PLANNING COMMISSION AGENDA

SUBJECT: American 1 Credit Union Site Plan

SITE DEVELOPMENT PLANS
JANUARY 20, 2023

SUBJECT: The Millhaven Site Plan

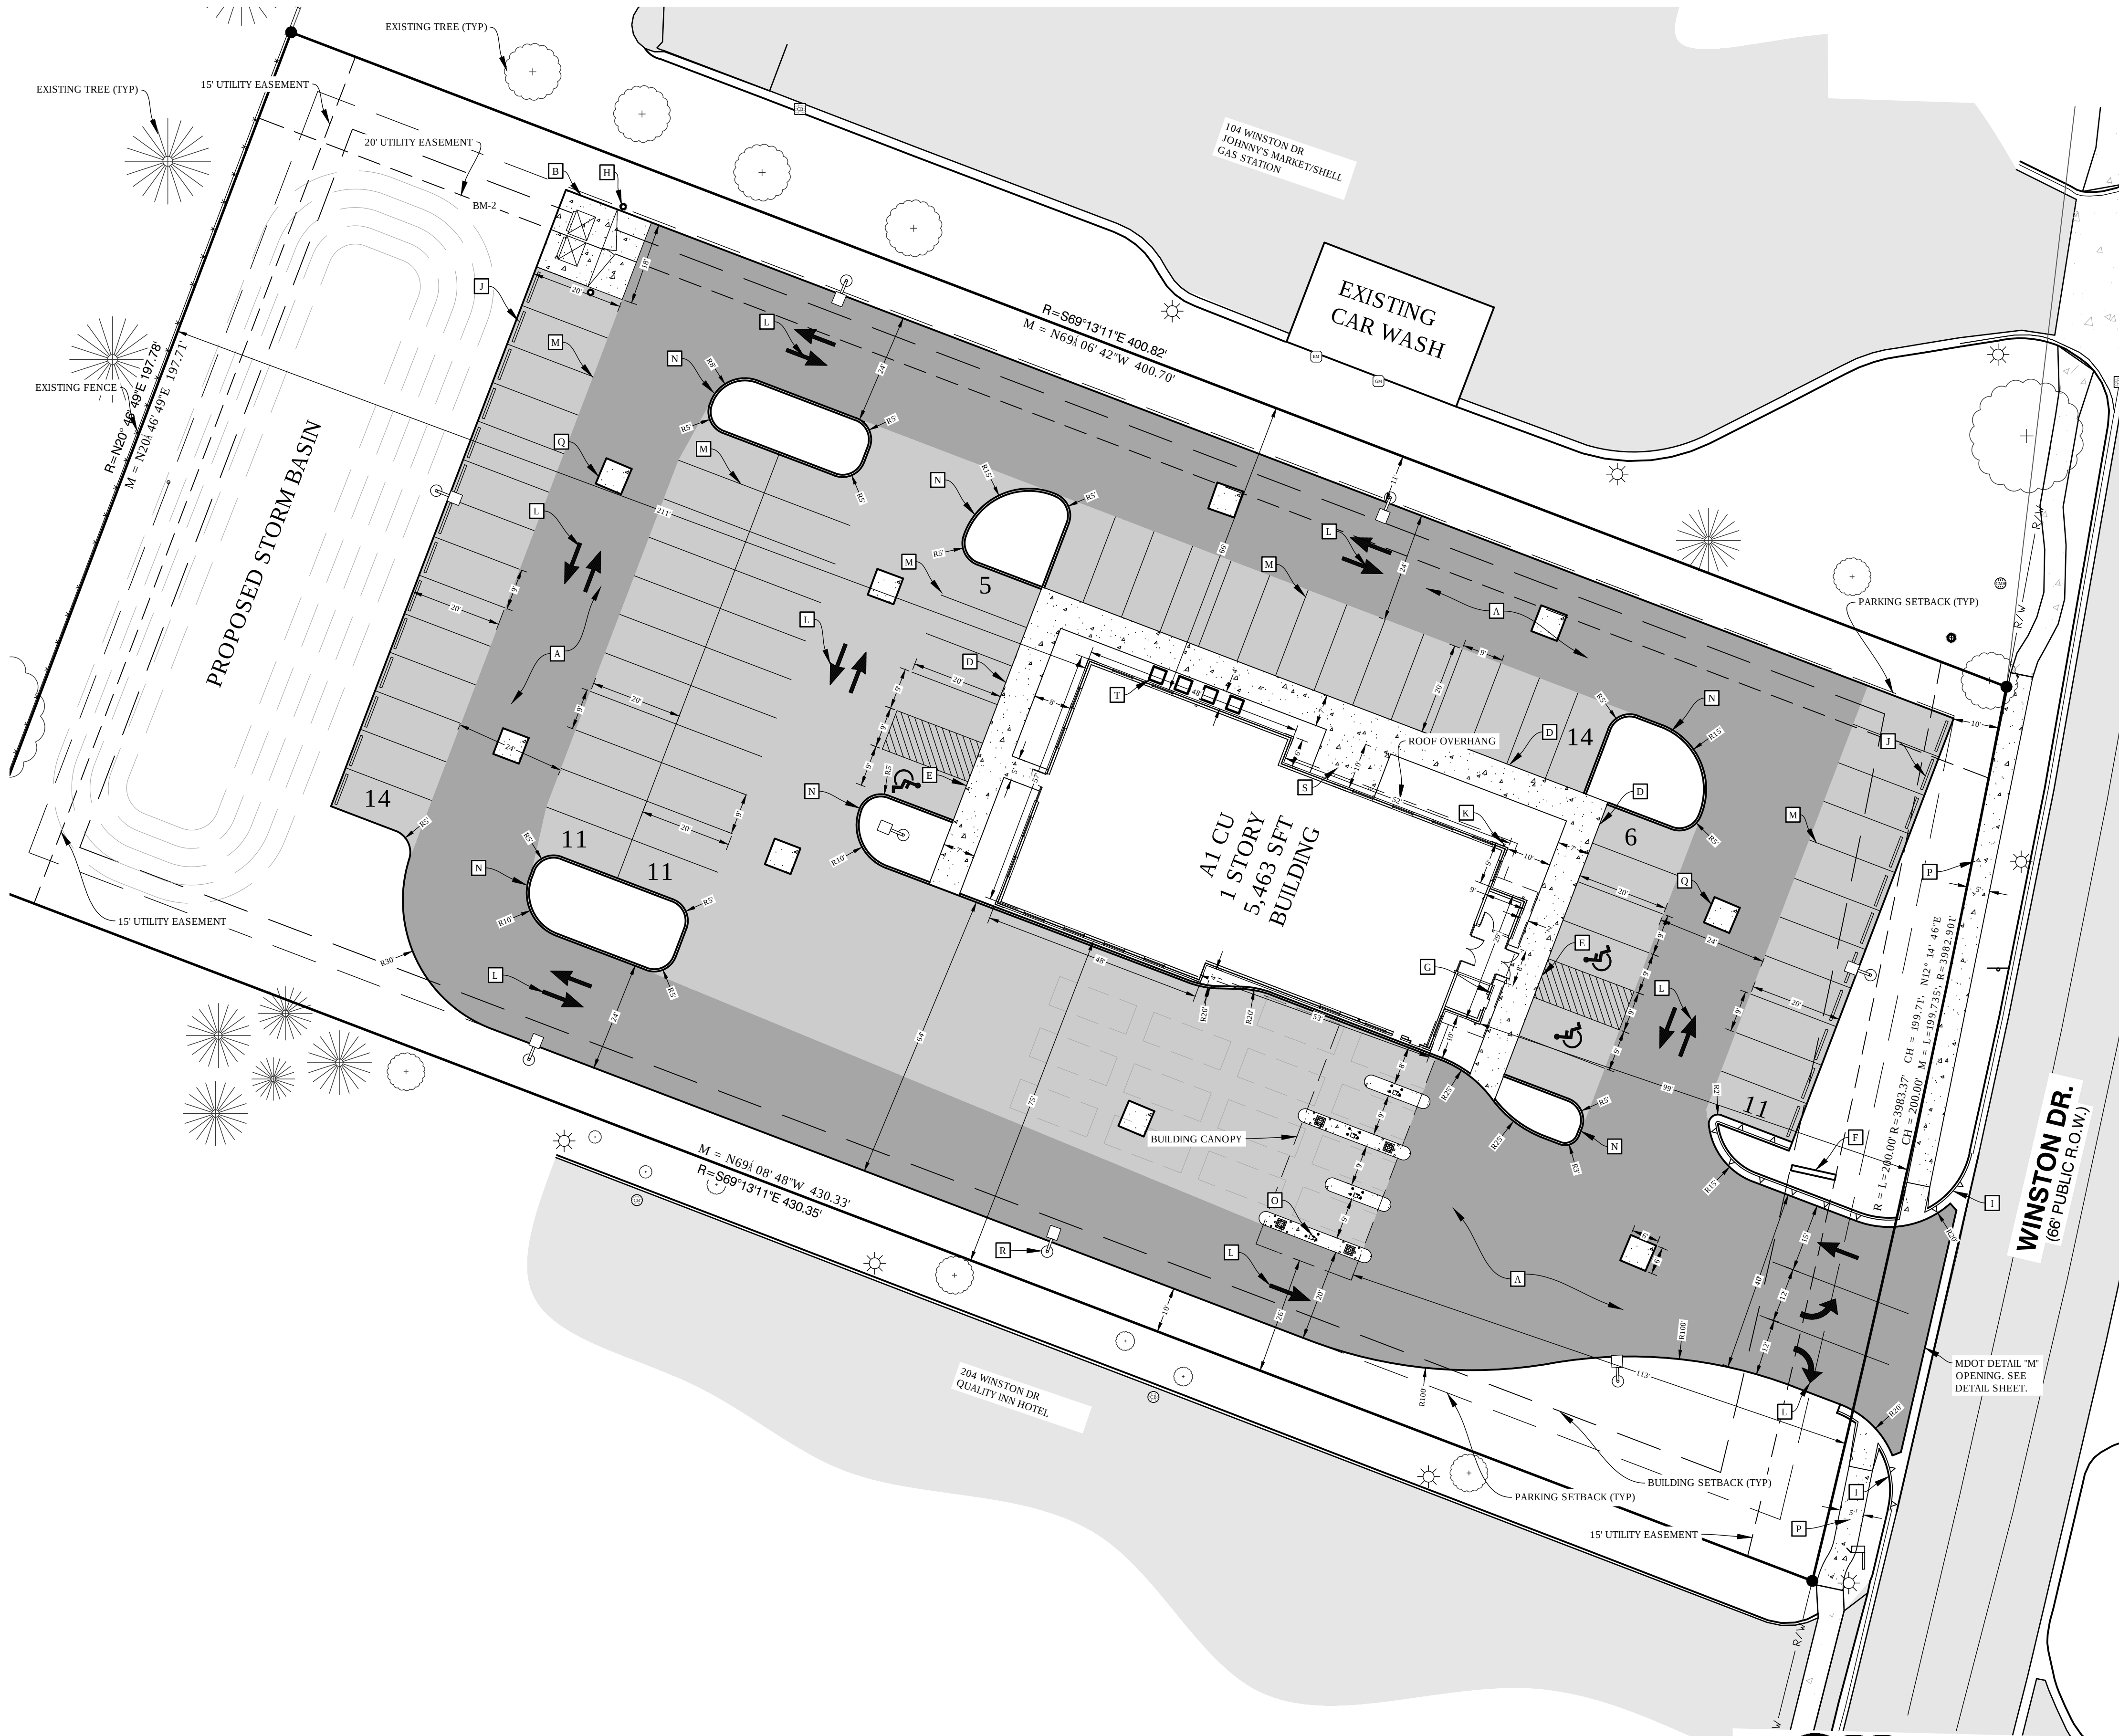
1. Knox box required at each building to ensure Fire Department access in case of an emergency.
2. Water and Sewer tap fees will be provided by City soon.
3. Current dumpster location blocks access to fire hydrant. Dumpster needs to be moved.
4. Only 16' from end of teller/ATM canopy to edge of curb. Fire lane of at least 20' is necessary. Fire Department concerned about canopy height in relation to truck height.
5. FiberNet requesting location to access building with new fiber line.
6. Review of storm and impact to neighboring properties in process. If determined that site plan may impact neighboring properties, curbing would be required around entire parking lot.

LANDSCAPE PLAN
MARSHALL AMERICAN 1 CU
COVALLÉ GROUP ARCHITECTS
106 WINSTON DRIVE
SECTION 27, T02S, R05W

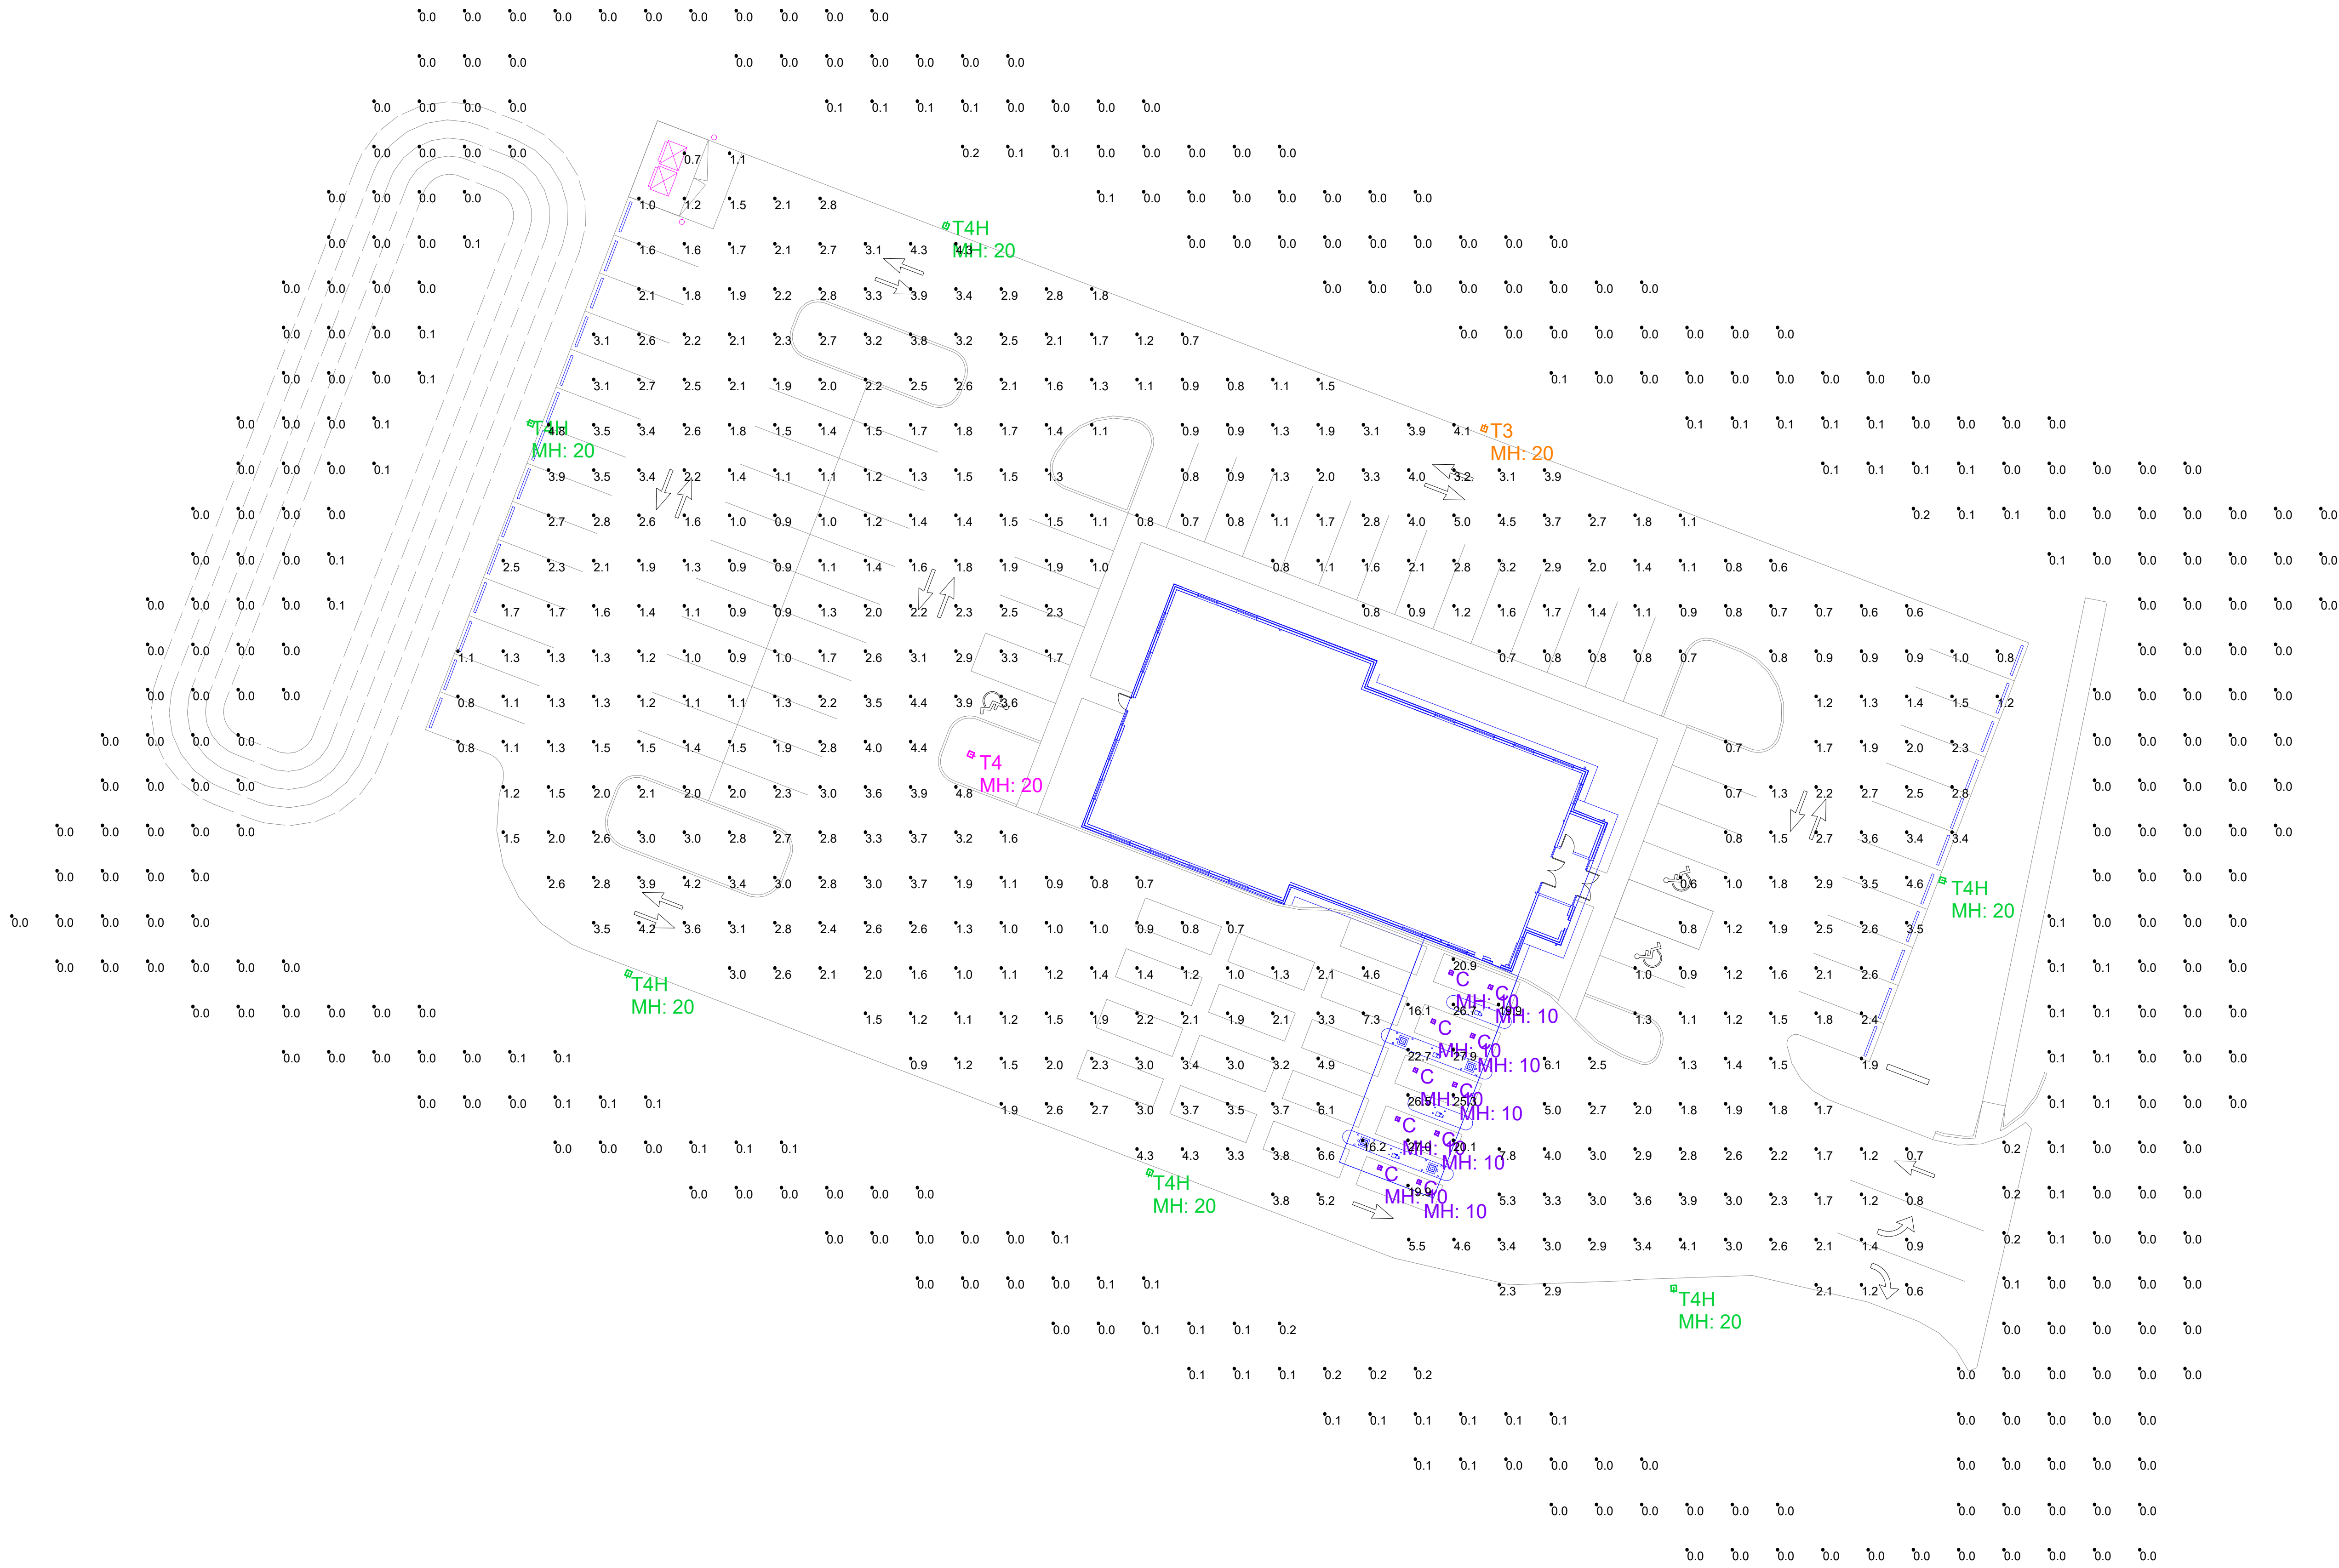
The submitted landscape plan was not stamped by a landscape Architect, as required by the Zoning Ordinance. I have requested this to remedied ASAP.

islands are supposed to be planted with lawn, perennials, ornamental grasses. Or shrubs, however, the proposed plan includes hardwood mulch instead.

- Screening from ROW- the required 10' greenbelt is included in the plan. The plan includes six trees, meeting the required number of trees for the just under 200' of frontage (5) and one extra in place of the shrubs that would be required.
- Parking lot screening- the lawn between the parking lot and ROW has a planted hedgerow of mungo pines and burning bushes.
